Environmental Protection Act 1994

Information request

Our reference: EPML00717813, A-PRCP-NEW-100758431

Attachment 1: Additional information requested for proposed PRC plan

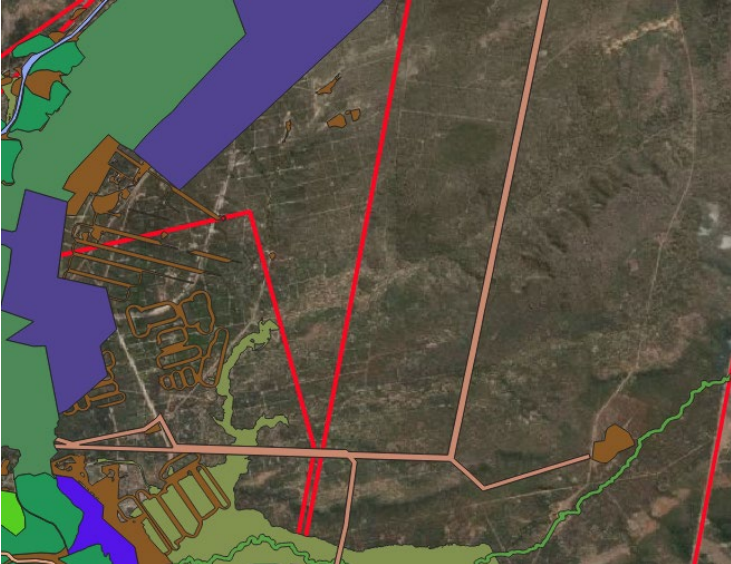
55.	Reference Map, Final Site Design and Spatial Data	The NPM response submitted to the administering authority on 16 May 2025 satisfied NPM Notice matters #5 – 7 (Reference Map, Final Site Design and Spatial Data). However further clarification is required regarding these matters.	Provide further confirmation Figure 1 includes general disturbance (Figure 1) or whether the disturbance relates to exploration. If applicable, update the Planning part and spatial data to include all areas of general disturbance.

Item	Relevant Section (proposed PRC plan)	Matter	Information Request
		As previously noted, general disturbance is required to be mapped as Rehabilitation Areas (RAs) and exploration disturbance is not subject to RA mapping. It is unclear whether the figure below includes general disturbance (Figure 1) or whether the disturbance relates to exploration. Particularly the wider roads/tracks, general disturbance contiguous with the mining activities.  <i>Figure 1: Exploration and track extents not clearly defined by the PRCP</i>
